CITY OF ALBUQUERQUE

April 24, 2015

**RE: Main Event, Pan American Freeway and Vassar Drive
Grading Plan and Drainage Plan
Engineer's Stamp Date 3-27-2015 (File: G16-D149)**

Based upon the information provided in your submittal received 4-01-15, the above referenced Grading Plan cannot be approved for Building Permit until the following comments are addressed:

| | GRADING PLAN | | DATE |

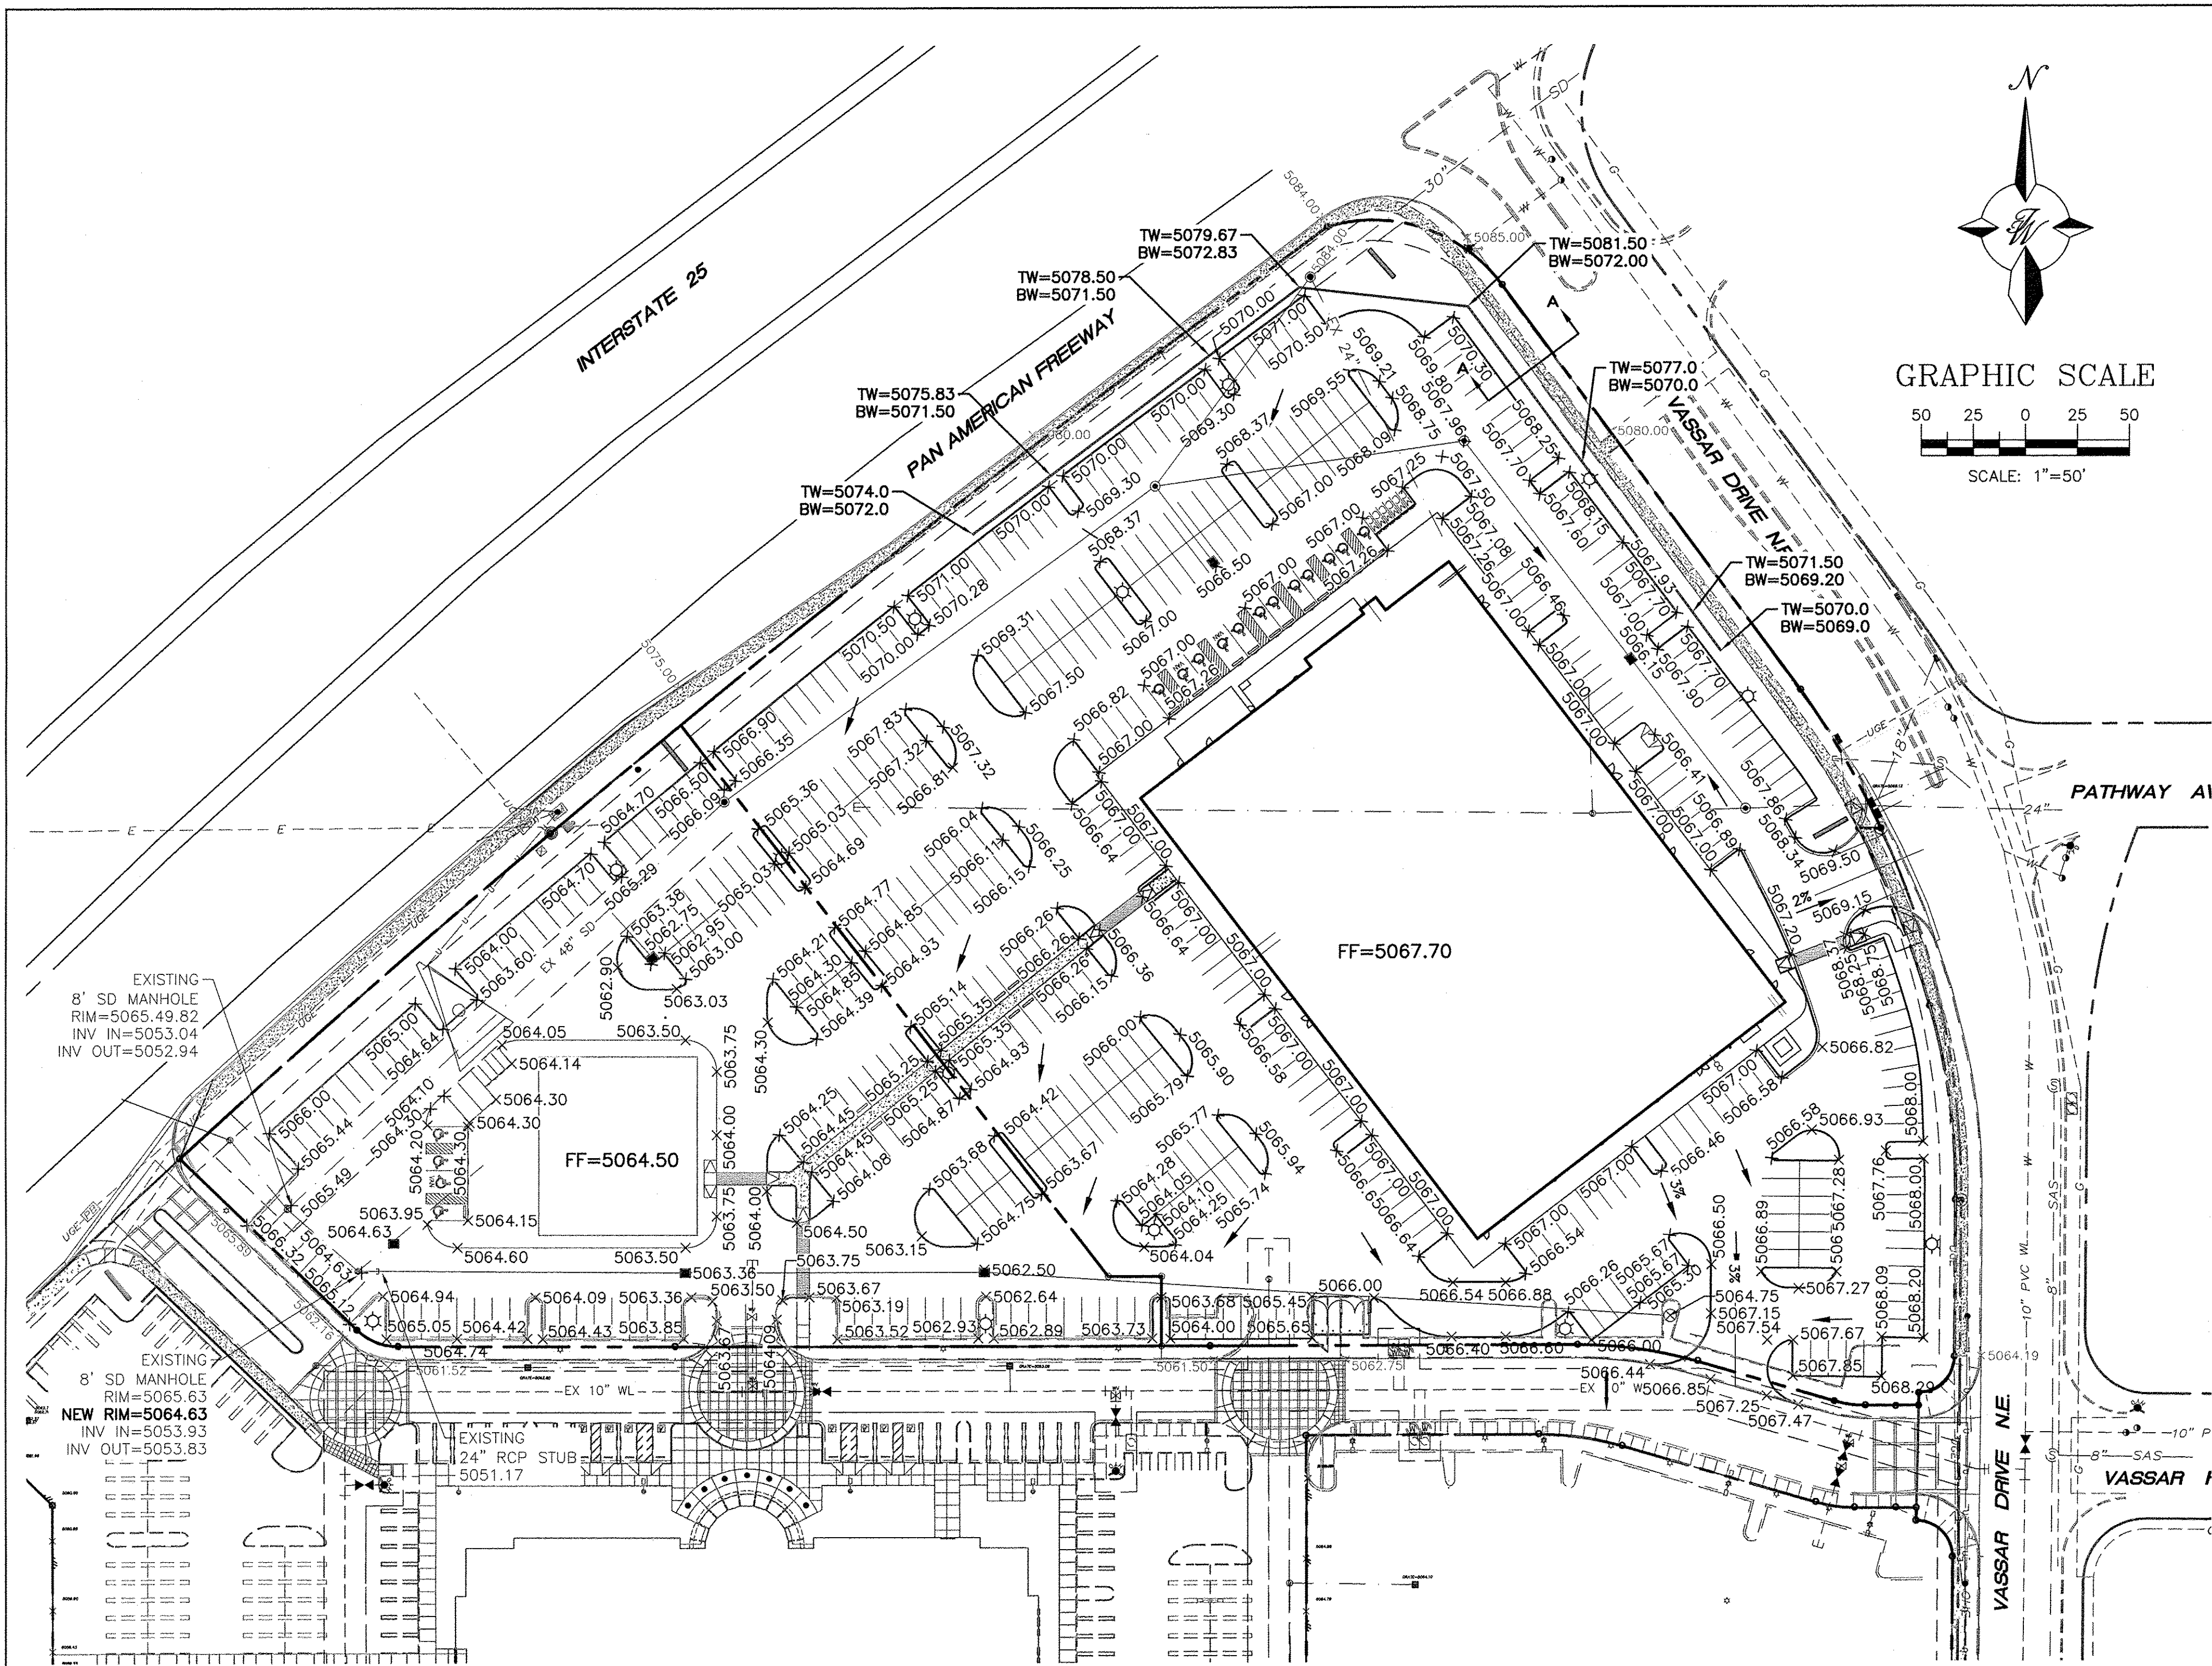
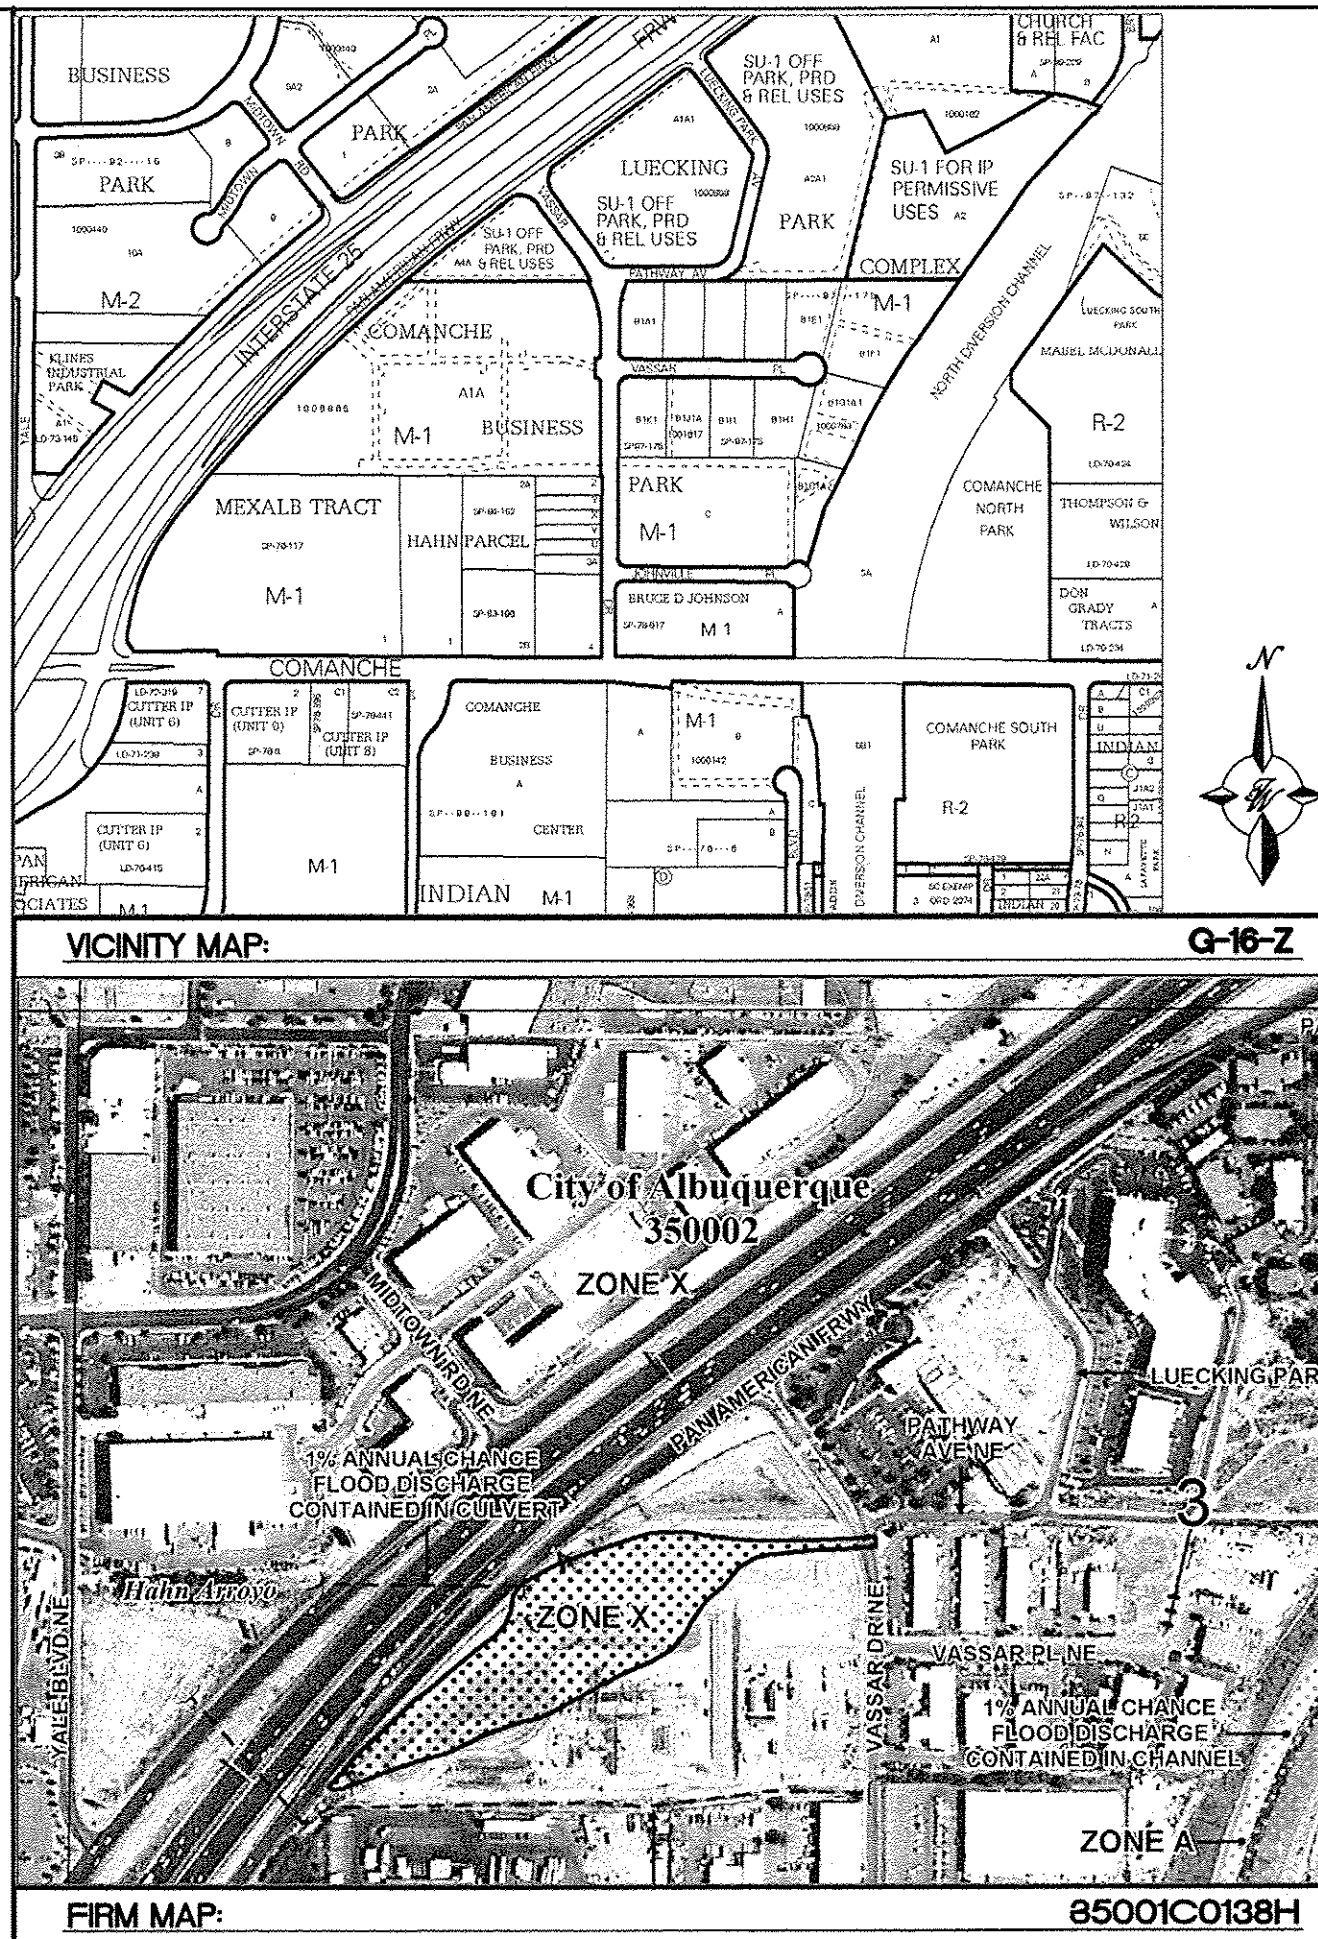
4) Include inlet capacity calculations within next submittal and inlet details. Show grate elevations for these inlets on the "Grading Plan" which correspond to the "Drainage Plan". There are a couple of discrepancies including a difference of about one foot between grate elevations and grade elevations at the same spot including two grates along the northwest side of the site that show grate elevations of 5063.75 and 5065.50.

5) Check the middle entrance to the private drive south of the building with regard to grade elevations. A couple of new spot elevations are shown to be 3 feet off from existing spot elevations, creating a very steep drop. Include more existing spot elevations within the public and private roads surrounding the site.

7) It looks like an approximate 3:1 slope is being created between the Pan American Freeway and the retaining wall along the parking lot. Provide Section A-A symbol on the plan view. There is an elevation discrepancy where the top of wall elevation is 5079.67, and there is an existing 5084.0 spot elevation as well as a 5086.90 for the new manhole rim elevation within very short distance from the wall.

9) Specify elevations in parking lot to be at bottom of curb if this is the case.

10) Show roof downspouts on smaller building similar to what you have shown for the larger building.
